**West Virginia Northern Community College
WESCO Building Renovation – M&G Project No. 16-008
Request for Bids No. 18002**

ADDENDUM NO. 2

August 16, 2017

SHEET
A1.1

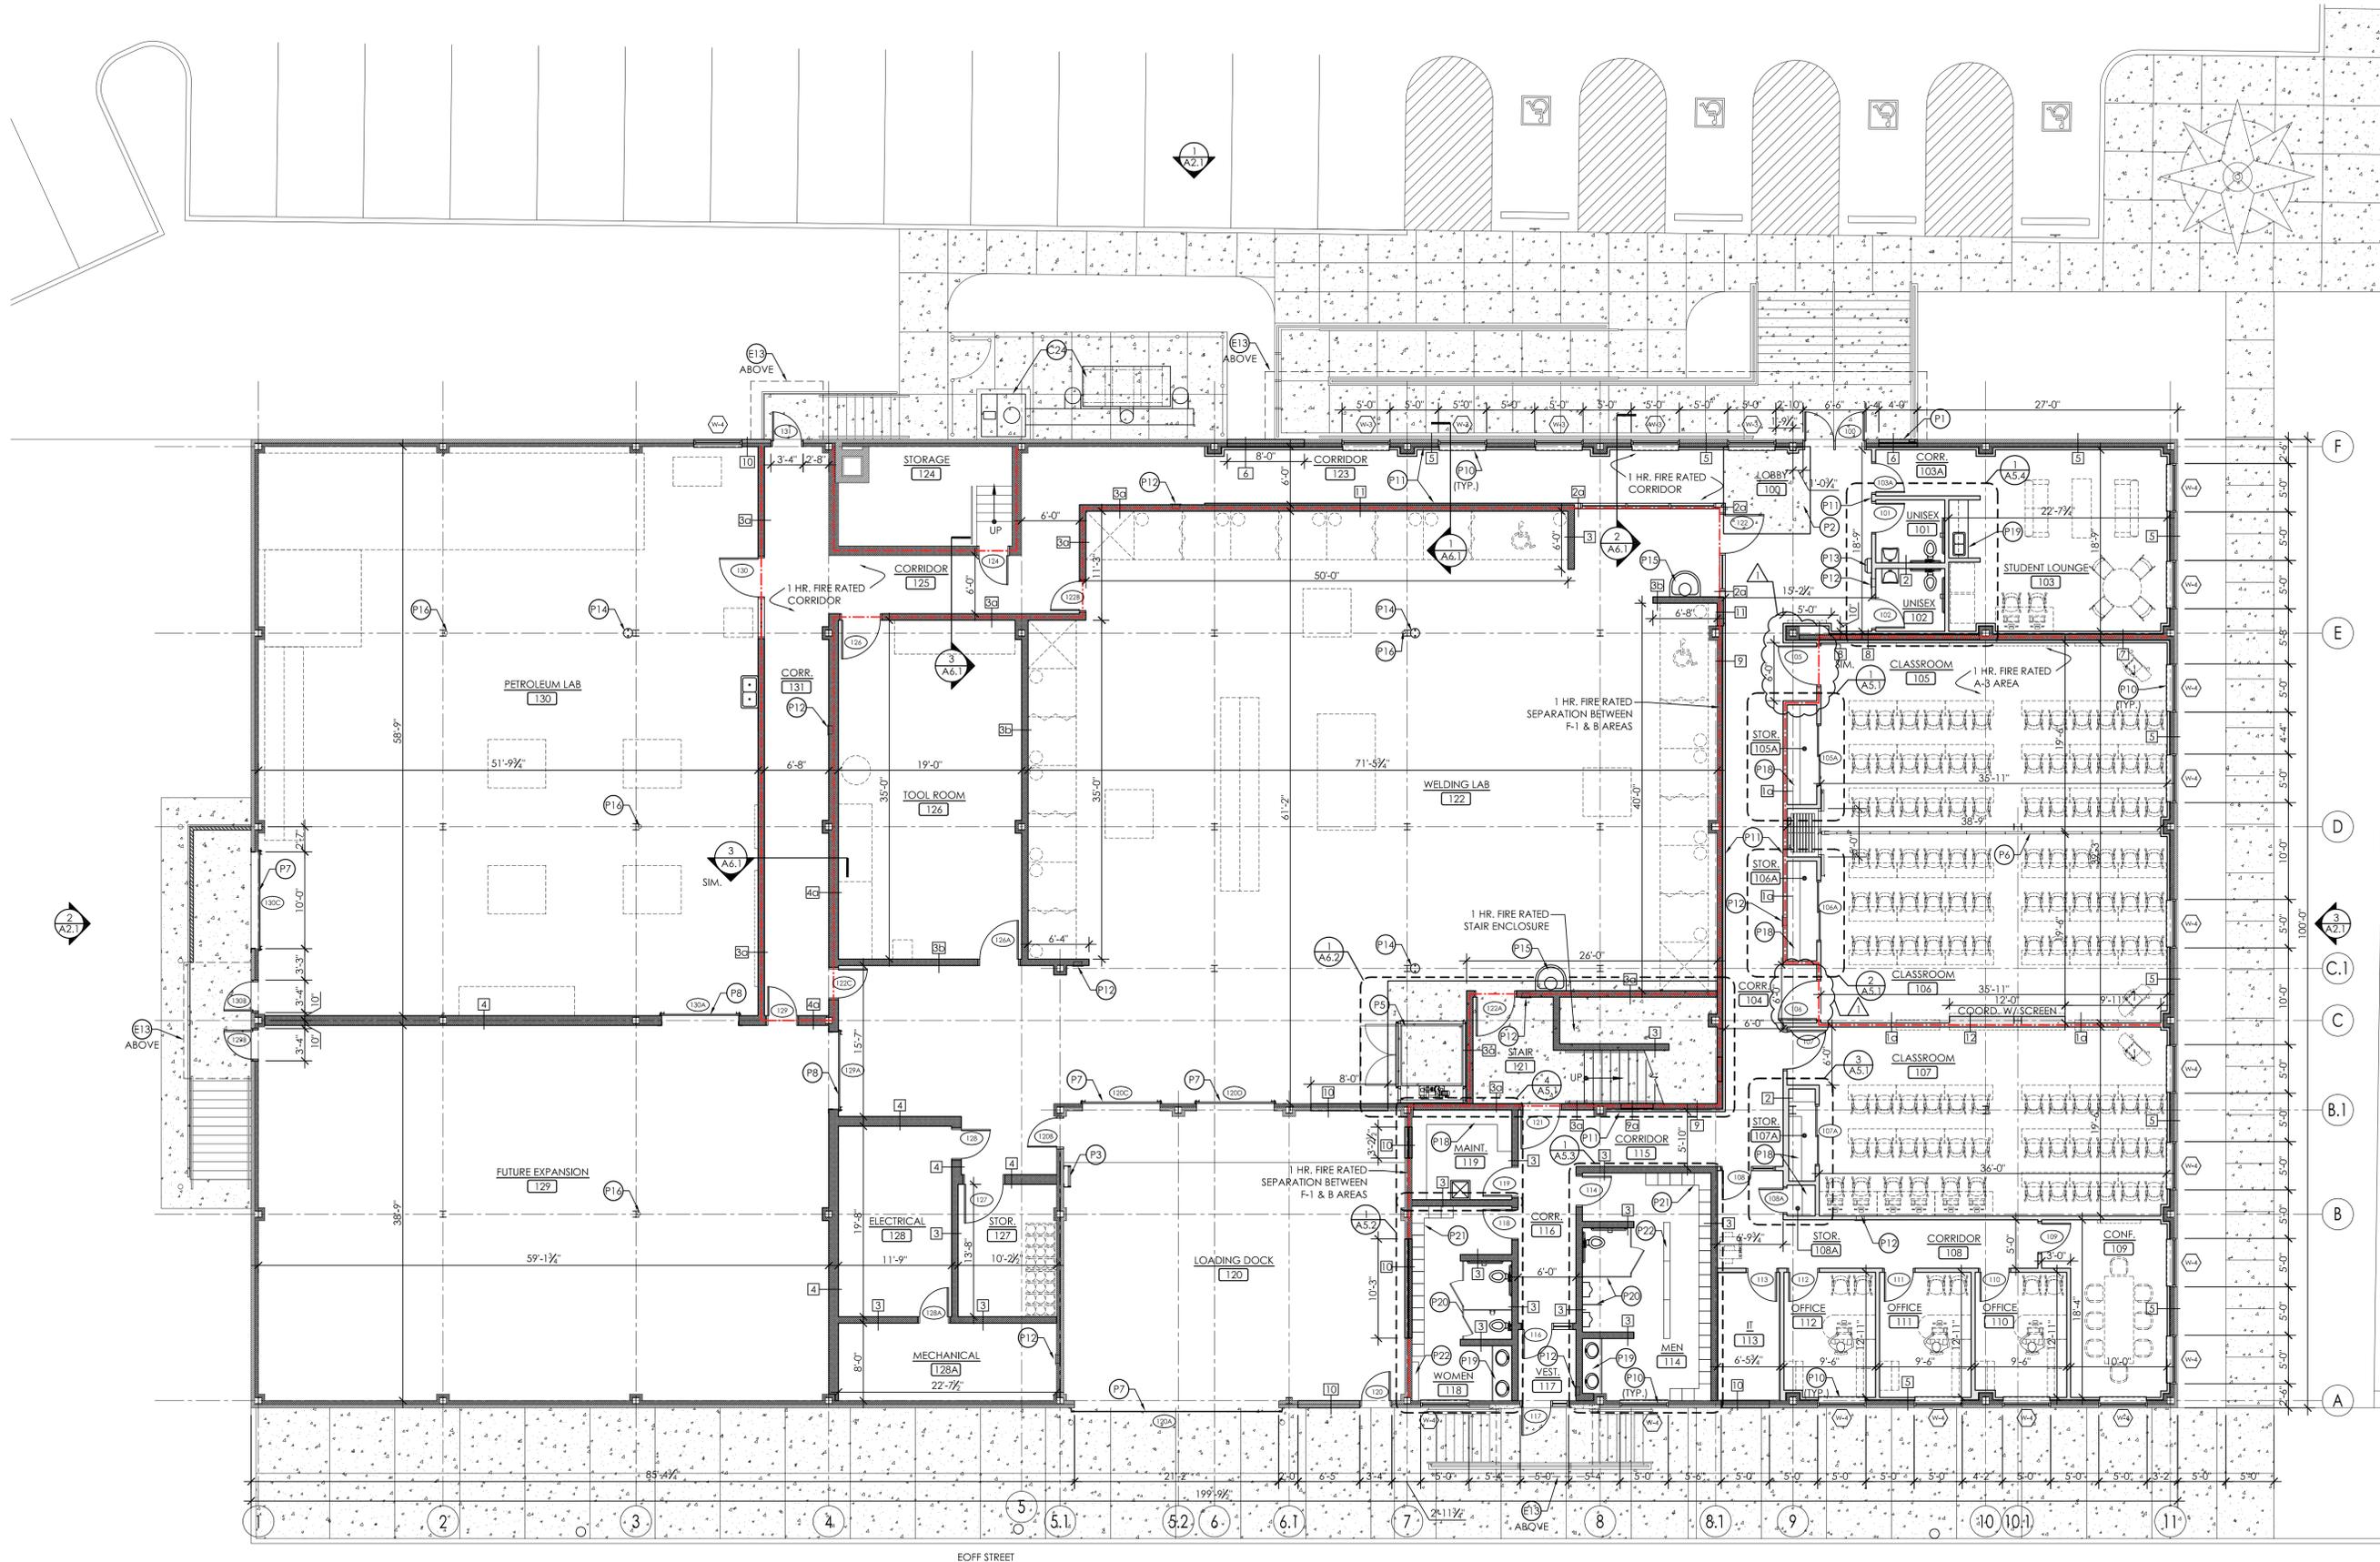
- B. Refer to attached revised drawings A1.1, A3.1 and A4.4, as well as revised Door Hardware Set 24, for changes related to reversing the swings of Doors 105 and 106 per the West Virginia State Fire Marshal plan review letter.

REVISION	
△	ADDENDUM 2 DOOR 105 & 106 - 8/15/17
